12 January 2026

Bayside Council submission on State Significant Development Application for 68-80 Beauchamp Road, Hillsdale (SSD-83256478)

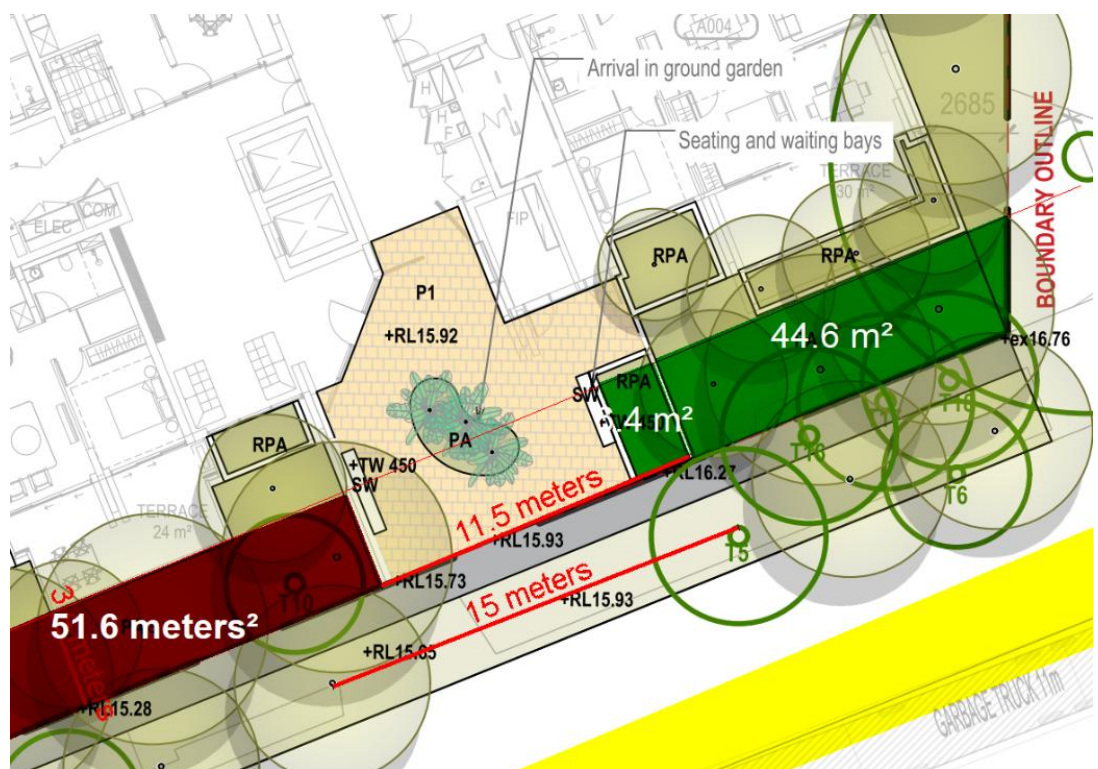
-) Undergrounding of all utilities (low and high voltage, telecommunications etc.) along the frontages of the development site and construction of underground supplied street lighting. This is a DCP requirement which Council consistently applies to new redevelopment of this scale.
- a) Demolition of existing footpath and construction of a new footpath and tree planting as per Council requirements along all frontages of the development site.
